Report: EVALUATION
Function: Test, Adjust, & Balance
Date: 10/31/2024
Completed By: National TAB

PROJECT
Chili's - Orlando, FL

Summary

Project Issue Information

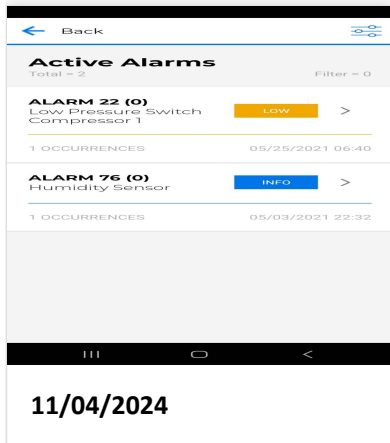
Issue Name : RTU#1 humidity sensor is not wired
Description : RTU#1 has humidtrol on its package details, however, there is no humidity sensor wired to the unit so it cannot dehumidify. Recommended to wire humidity sensor per manufacturers specifications (i.e., two separate shielded twisted pairs required).
Created By : National TAB **Assigned To :** National TAB - Ian Fuller
Status : Open
Priority : Urgent **Asset Tag :**
Originated Date : 11/04/2024 - Ian Fuller - National TAB

Project Issue Information

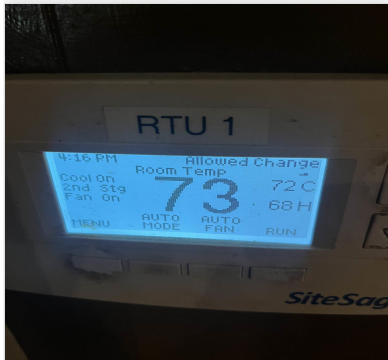
Issue Name : RTU#3 thermostat display is not functional
Description : Thermostat display does not work. Staff is unable to control temperature in space. Recommended to replace thermostat.
Created By : National TAB **Assigned To :** National TAB - Ian Fuller
Status : Open
Priority : High **Asset Tag :**
Originated Date : 11/04/2024 - Ian Fuller - National TAB
